Re: Wroxeter Estates – Major Sketch  
Subdivision #2017-018; Project #2017-0066-00-NS  
TM 39 BL 9 Parcels 51

The Sketch Plan for the referenced project has been reviewed by the agencies listed below and copies of their comments are attached.

SUBJECT: Wroxeter Estates  
Subdivision Number S 2017-018; Project Number P 2017-0066 00 NS  
Sketch Plan Review

**Overlay of 1847 USGS Coastal Survey on subject property**

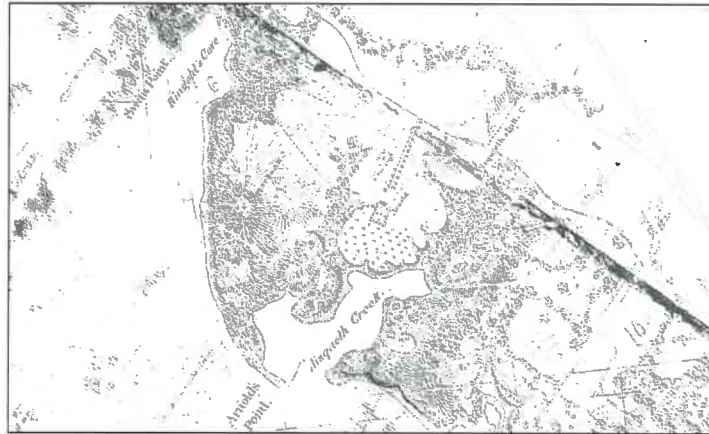
The project area contains undocumented historic structures (aged 50 years or older) on a property that archival and cartographic evidence indicates is a historic farmstead that belonged to the Arnold Family, one of the early settlers of the County. An overlay of the 1847 USGS Coastal Survey map shows that the property maintains much of its character from the 19<sup>th</sup> century (see images below). Tax records suggest that the primary structure was constructed more than a century ago. Given the substantive archival evidence and the current condition of the property, there is very high potential that it contains existing cultural resources that may require documentation and/or mitigation prior to approval for development. **Further information is needed prior to subsequent review. A site visit is required by the Cultural Resources Division to evaluate potential impacts from the proposed development.**
